Product Change Notice

PCN Number: 70871-H1-002		Revision: A		Date of Publication: 04/08/2014
PRODUCT NAME	PRODUCT PART#	OLD — REV. — NEW		REVISION TYPE
BC77Q	70871-C	1.0	1.1	Hardware

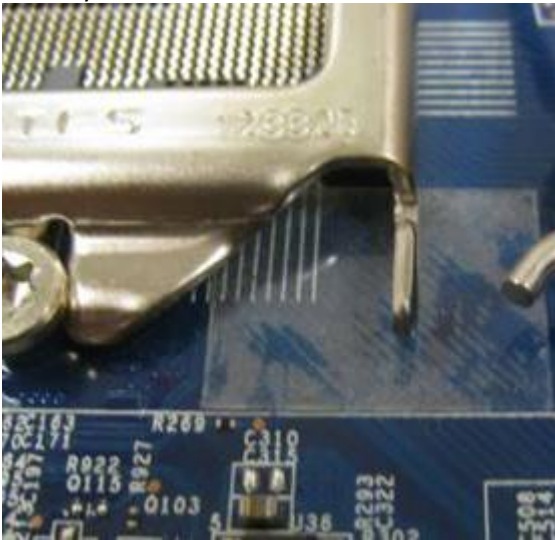
Prevent the lever handle on the CPU socket from damaging the traces on the motherboard during installation of the CPU.

Add Mylar underneath the CPU socket lever handle.
